**Location**  
Project wide  
London

Works plan and section  
Beckton Tunnel sheet 59  
Book of plans - section 1  
DCO-WP-000-ZZZZ-010060 - Rev 2  
JULY 2016

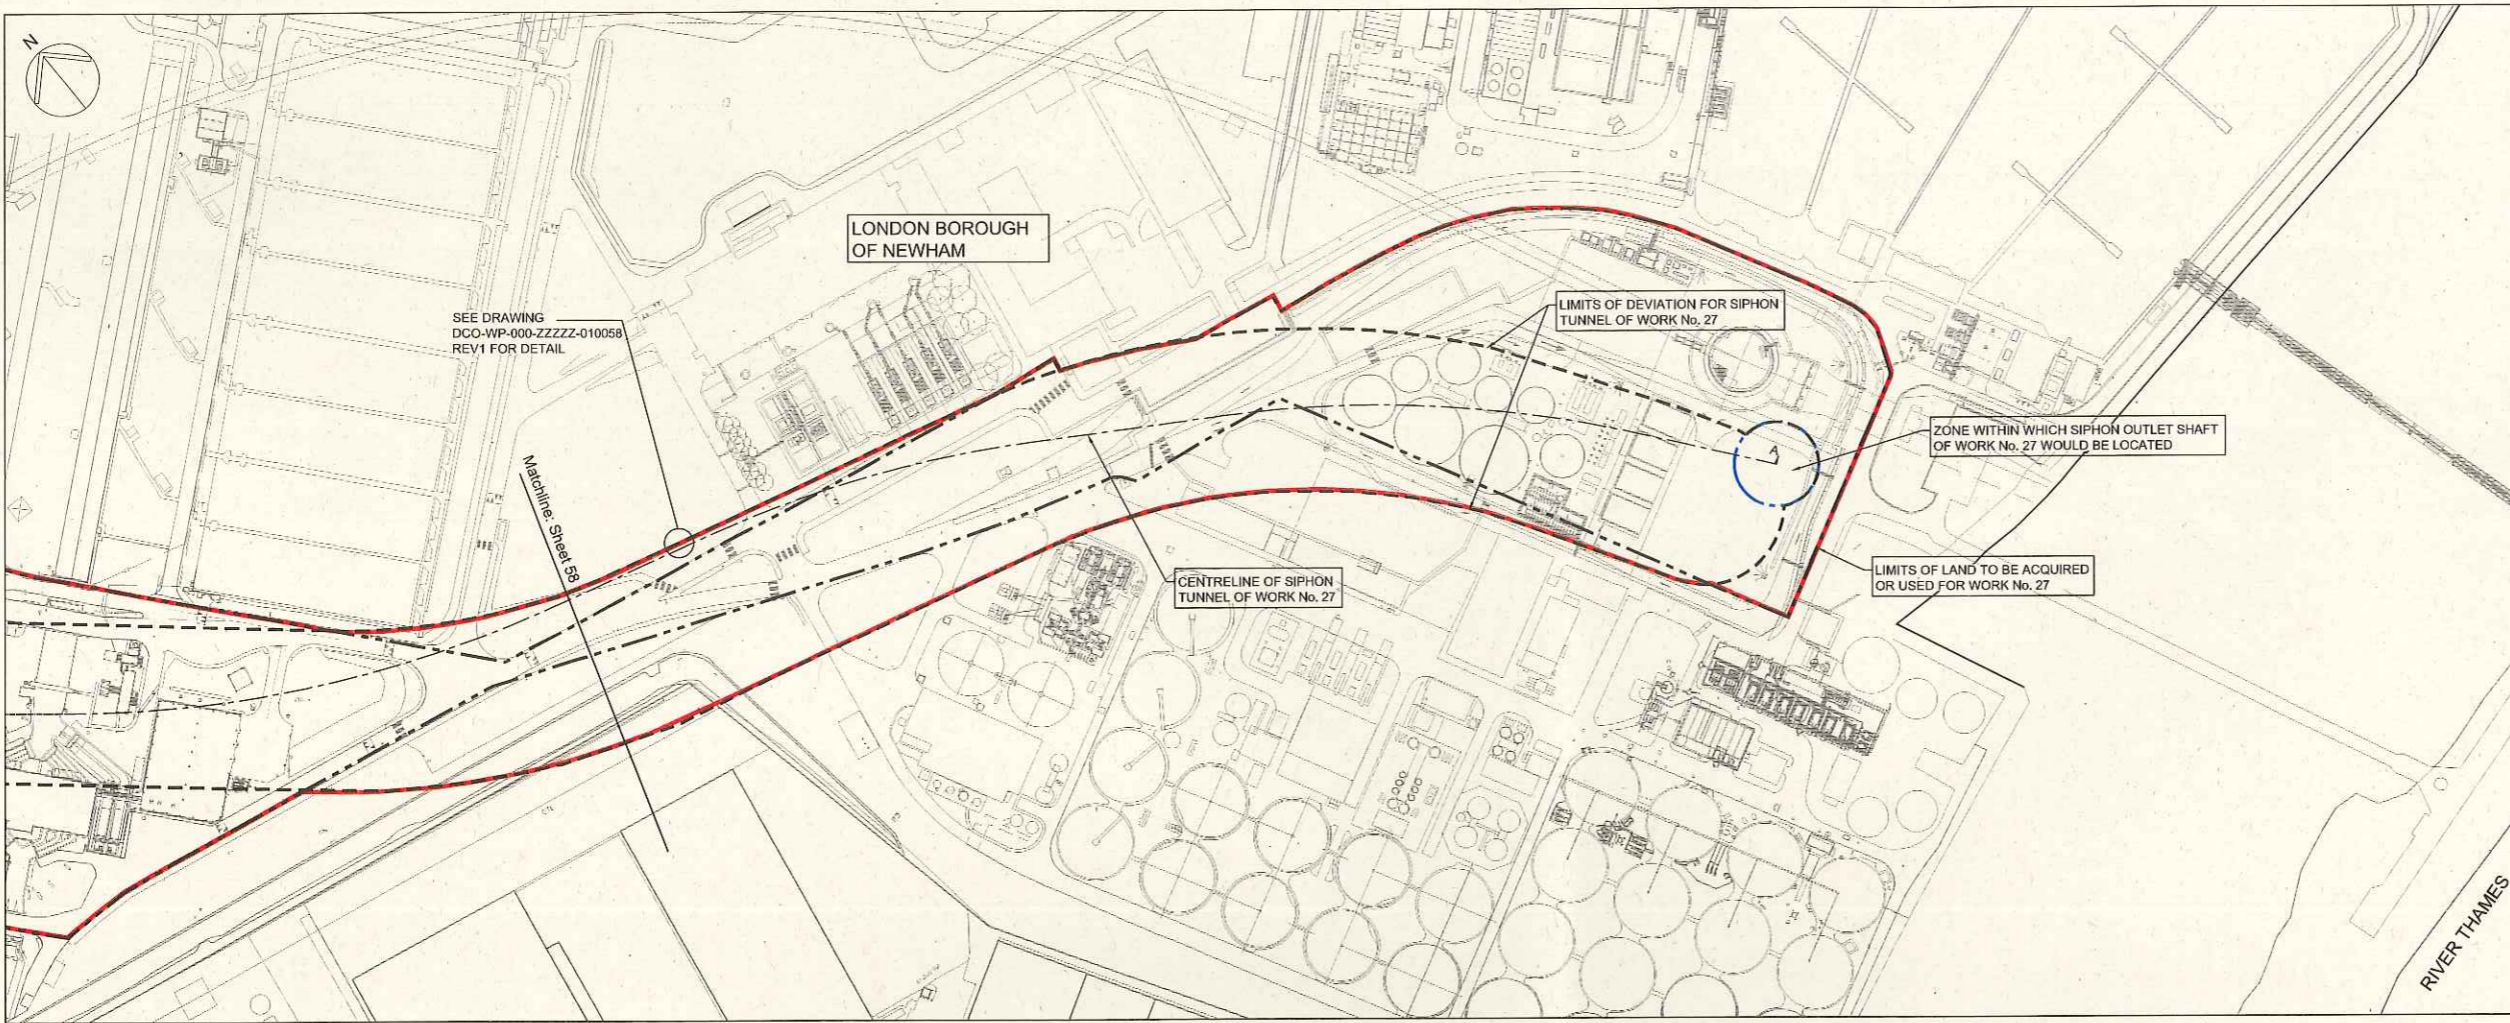
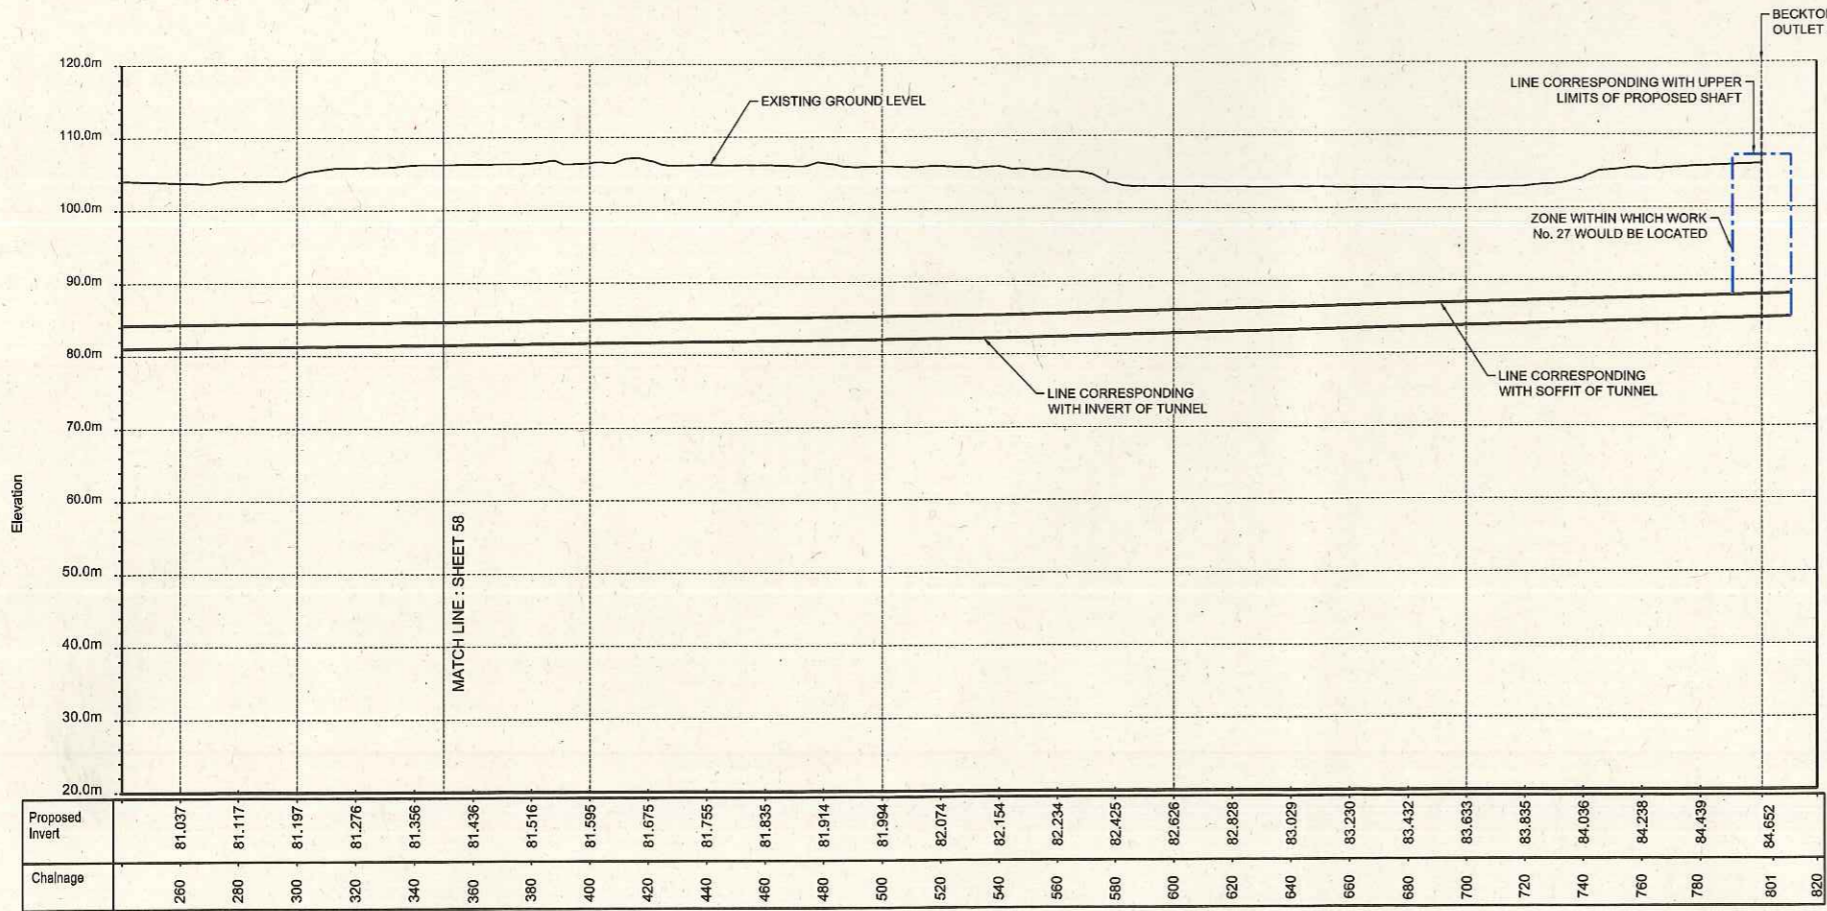
- Rev 1:**
1. CENTRELINE OF SIPHON TUNNEL CORRECTED
- Rev 2:**
1. CENTRELINE OF SIPHON TUNNEL MODIFIED.
  2. ZONE WITHIN WHICH SIPHON OUTLET SHAFT OF WORK No. 27 WOULD BE LOCATED HAS BEEN MOVED.
  3. INVERT AND SOFFIT OF TUNNEL RAISED BY APPROXIMATELY FIVE TO SEVEN METRES.
  4. SIPHON TUNNEL LENGTH INCREASED BY APPROXIMATELY 20 METRES.
  5. TUNNEL LIMITS OF DEVIATION EXTENDED AROUND NEW OUTLET SHAFT ZONE LOCATION.
